Swan soundbar

Speaker cable drawings for control run + Pre-MP + MP(~15K)

Issued Date 2021.08.24

Ver.1.0

SPEC_4AI20-CMXX04 – Left channel speaker cable

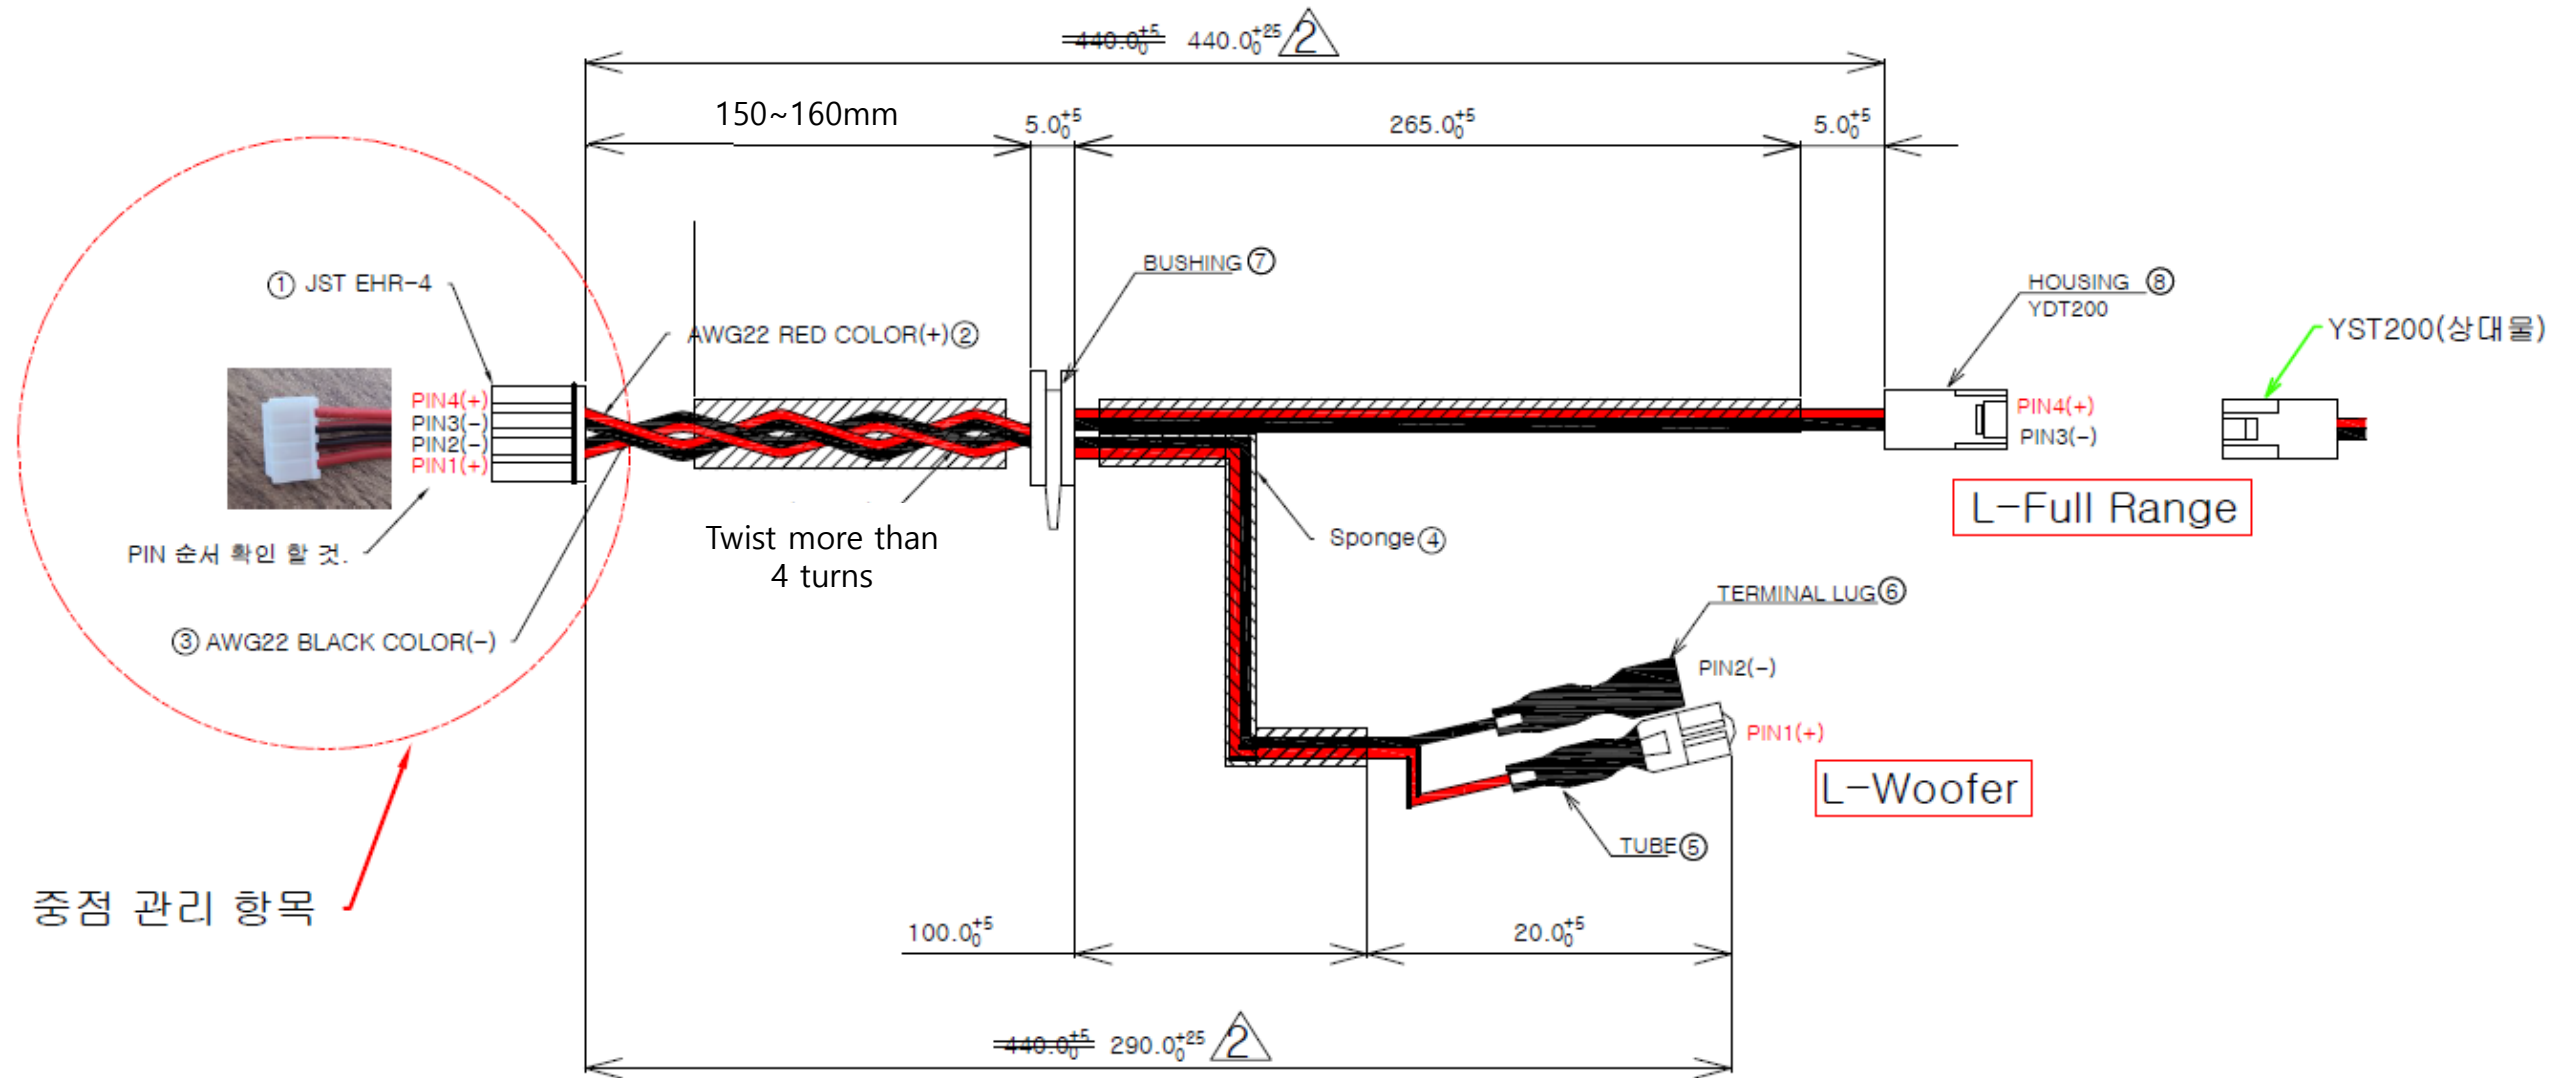
- Due to cable twist **rework by hand**, twist length may vary.
- Rework cable will be supplied up to 15K production.
 - After 15K, will be supplied the drawing dimensions by **machine work**.
- Request to factory
 - Skip the IQC on cable twist spec
 - If the cable twist less than 3, please twist more when final assembly
